MODIFICATION REPORT: ARCHITECTURAL MODIFICATIONS TO SSD-10371

Prepared by Willowtree Planning Pty Ltd
on behalf of The Council of Trinity Grammar School c/-
Bloompark Pack PM

| Document Control Table | | | |
|----------------------------|---|--|---|
| Document Reference: | WTJ22-431 | | |

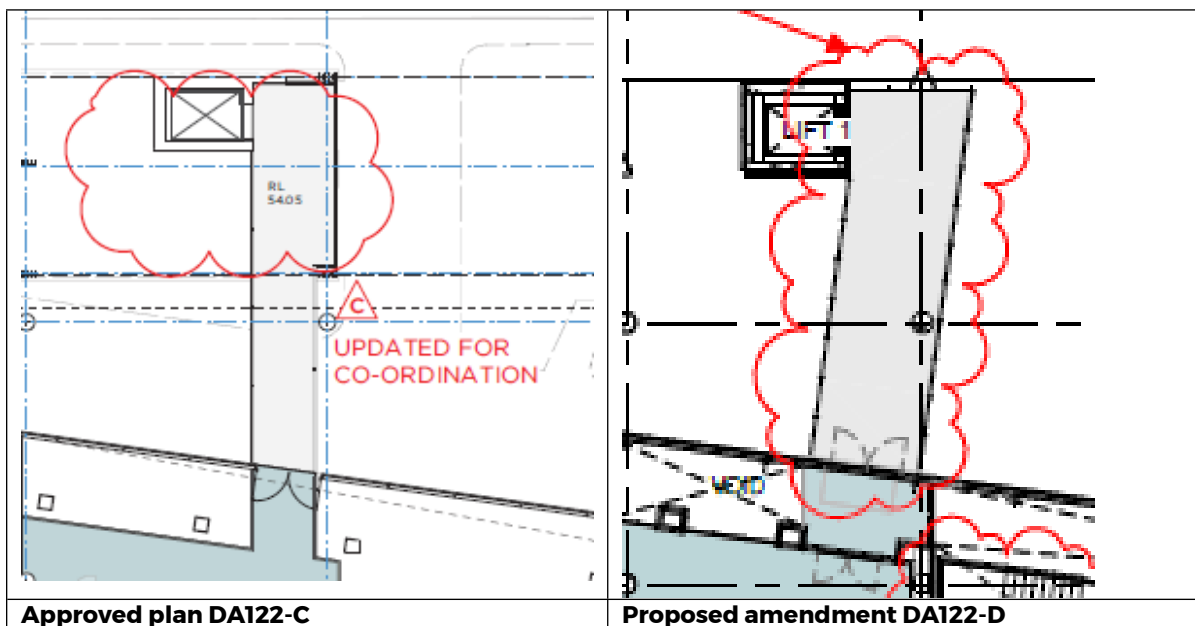
- Replan of Library / Senior Leadership offices;
- Internal stair modifications; and
- Internal wall modifications

These amendments are contained within drawing reference **DA122-D** and set out in the accompanying design modification schedule produced by TKD (**Appendix 2**). These modifications are internal to the building and have no material environmental impact. This internal reconfiguration will not impact on the design quality of the extant planning consent.

- **Amended bridge between Lift and Library.** The proposed plan form for this bridge offers improved structural efficiencies with the proposed concrete structure.

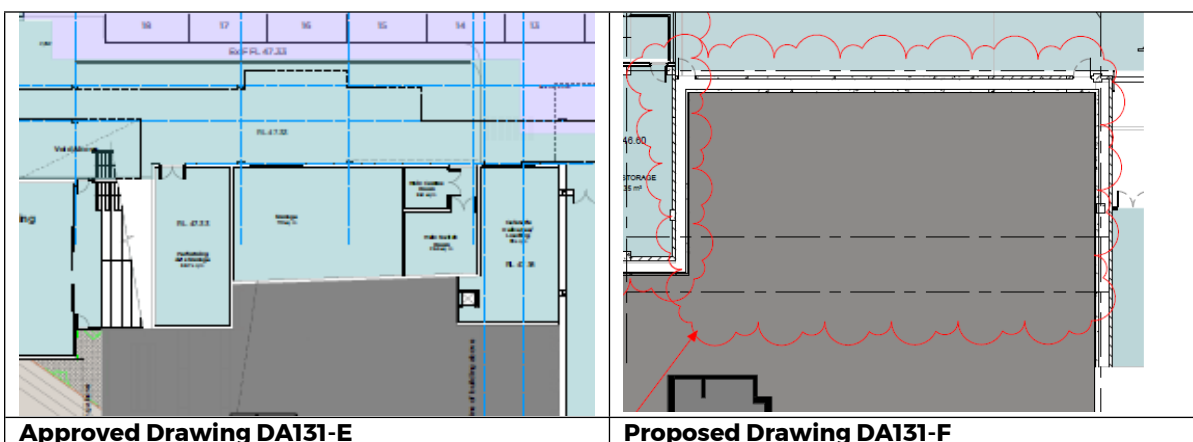
- **Existing music building ground floor replan.** The school have developed their requirements for this level of the existing Music Building. Their operations will require a co-curricular office, drama studio and office, locker space, plant, storage and amenities as shown in this proposed amendment. These amendments are contained within drawing reference **DA131-E** and set out in the accompanying design modification schedule produced by TKD (**Appendix 2**). These modifications are internal to the building and have no external manifestation or material environmental impact. **Refer to 5-DA131 on Plan DA131-E**
- **Practice room replan.** The school have requested a large and small percussion room next to the plant room. It is proposed to relocate the plant room further south so that the two percussion rooms are next to each other for operations. There are no detrimental

environmental impacts proposed as a result of this modification. An addendum to the acoustic report is contained within **Appendix 2** which confirms that the development as modified would not give rise to any material environmental effects. **Refer to 2-DA132 on Plan DA131-E**

- **Landing replan.** Design development requires configuration of the landing and doorways. **Refer to 1-DA133 on Plan DA131-E**

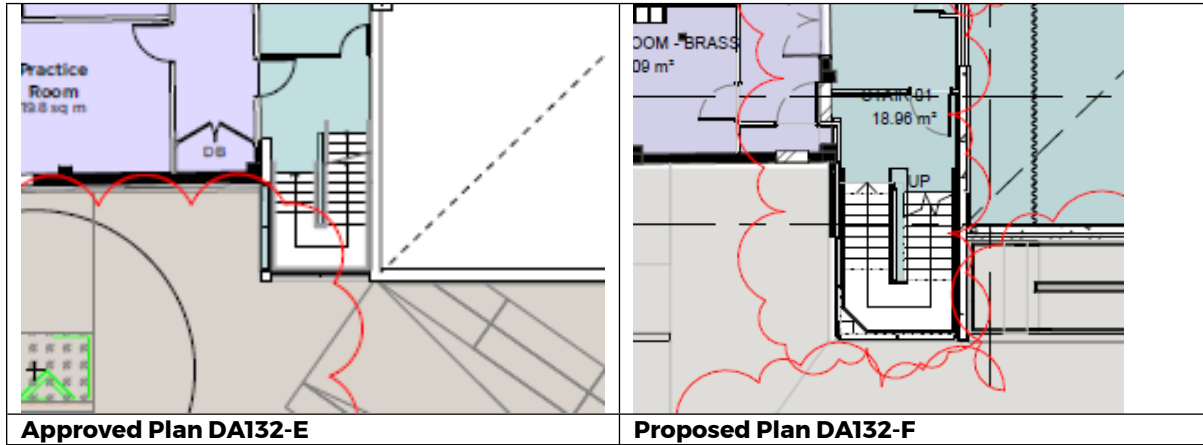
- **Deleted storage and relocated Main Comms and Switch rooms.** The school have reviewed their storage requirements on this level and concluded that the storage approved here is surplus to their requirements considering proposed storage in the Teaching Learning basement (refer 3 - DA120). Design development has shown that the Main Comms Room and Main Switch Room can also be accommodated there. This modification proposes not to have any basement space below the canteen and has the added advantage of reducing the need for excavation. Given there is a reduction in the extent of excavation there is no material environmental impact. The modification is contained within the basement and have no external manifestation.

- **Stair replan.** See modification 3-DA132. The stair will protrude from the wall and is required as a result of design development. The redesign will be contained within the Site and will not have any material or environmental impacts. The design is inkeeping with the prevailing design at the Site.

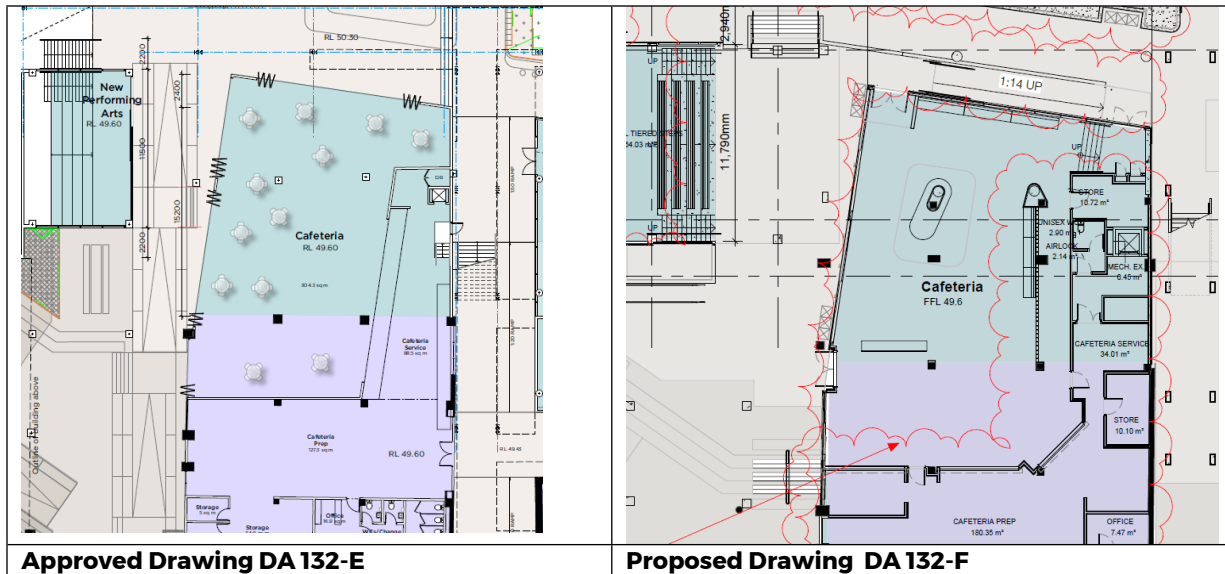
- **Cafeteria precinct replan.** The school require an undercover outdoor area adjacent the Cafeteria where students can queue for their lunch orders at peak times and eat their meals sheltered from the weather. This proposed area will provide that with large parts on grade with the Cafeteria floor and connected via large openable glazed walls. This area is directly linked to the tiered seats facing the Black Box and those overlooking Oval 1 to provide a variety of seating opportunities. The proposed 1:14 ramp to the west provides equitable access from the Oval 2 level.

Furthermore, Design development based on kitchen consultant advice has generated the proposed kitchen layout to meet the school's operational requirements.

Proposed Plan DA133-C

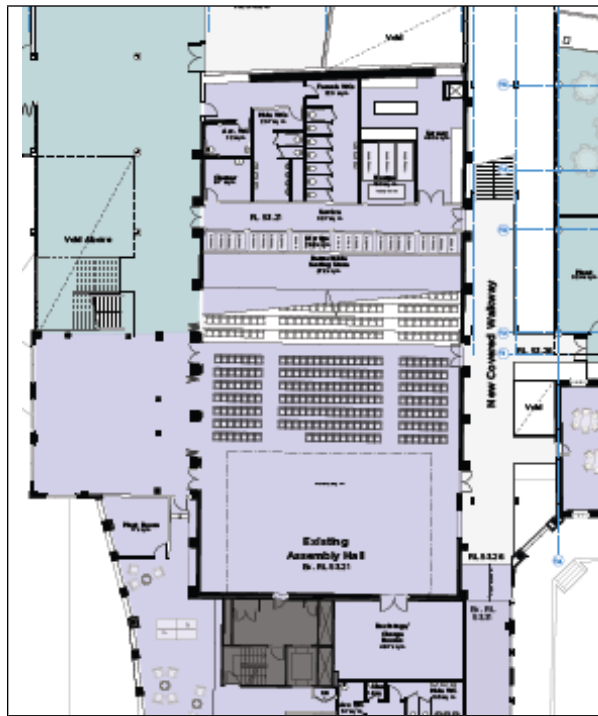
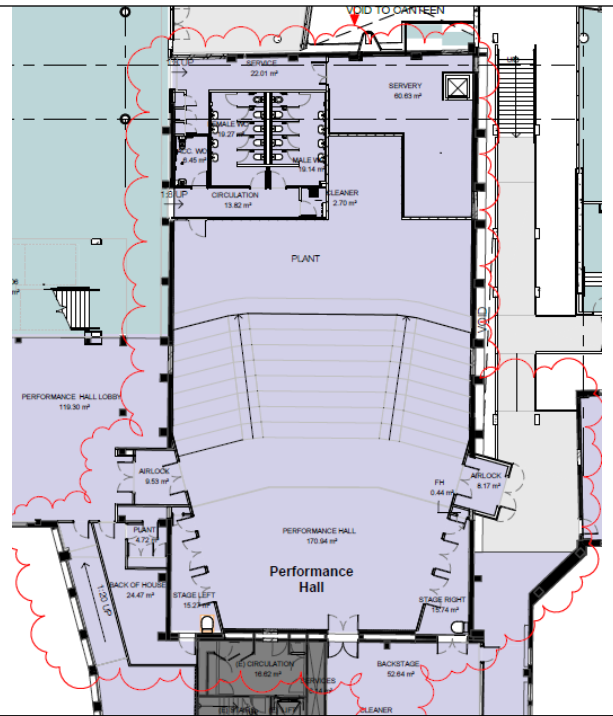
To complement their extensive music program, TGS have requested that the current Assembly Hall be converted to accommodate musical and theatrical performances by the students for the school community. The proposed planning changes arising from this brief include – raked tiered permanent seating; separate wings with associated backstage areas and rigging over; airlock entries with associated circulation outside the hall and a new control room at the rear of the auditorium.

The acoustic fabric of the hall is proposed to be upgraded with a new roof build up on the existing steel structure and all existing windows replaced with blonde face brick to match existing walls. These amendments are supported by an acoustic statement contained within **Appendix 8**

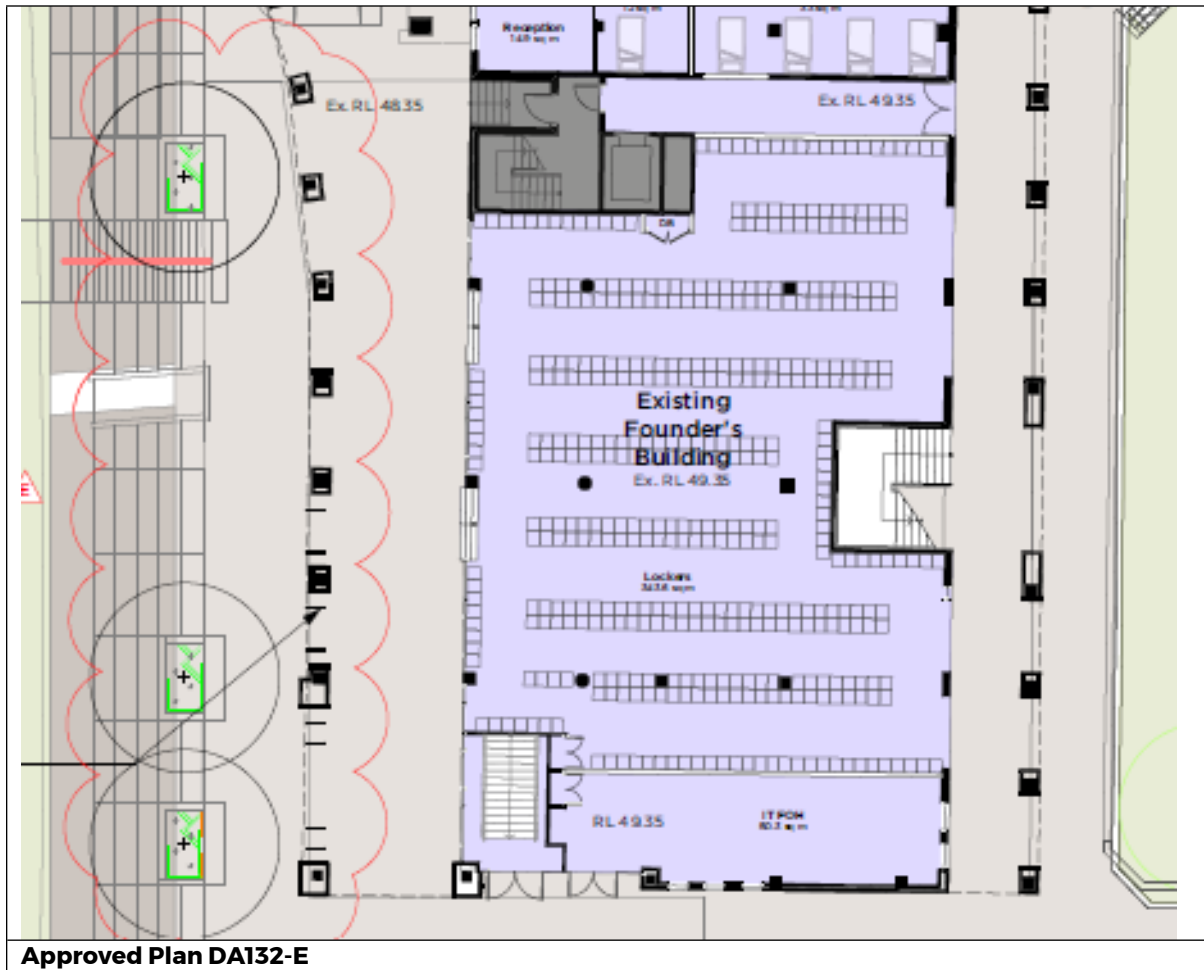
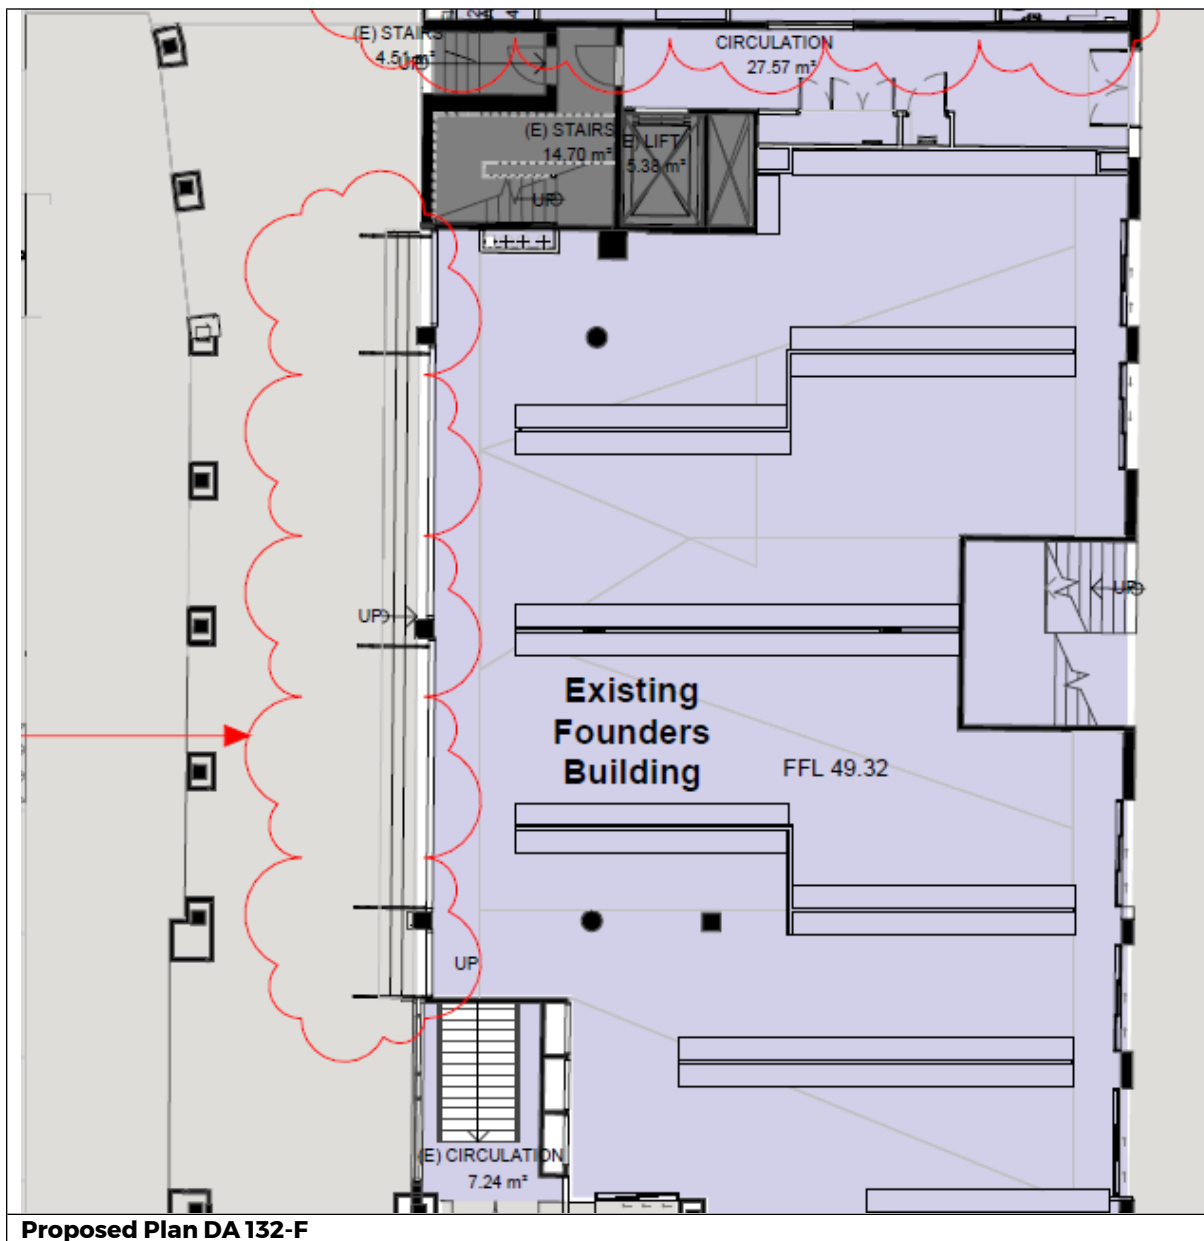
- **Health centre replan.** The proposed plan reflects the school's current requirements for the operation of this centre. It accommodates amendments to the cafeteria prep area (refer 7 - DA132) and associated campus amenities.
- **Locker room stairs.** Design development has considered the location of stairs here to connect the locker room with the adjacent colonnade. New stairs within the building envelope would need to cut into the existing slab set down here. It is proposed to locate the new stairs in the colonnade to avoid the risk of compromising the structural set down. The stairs will not conflict with the overall design intent of the building and will be in-keeping with the overall design for the school.
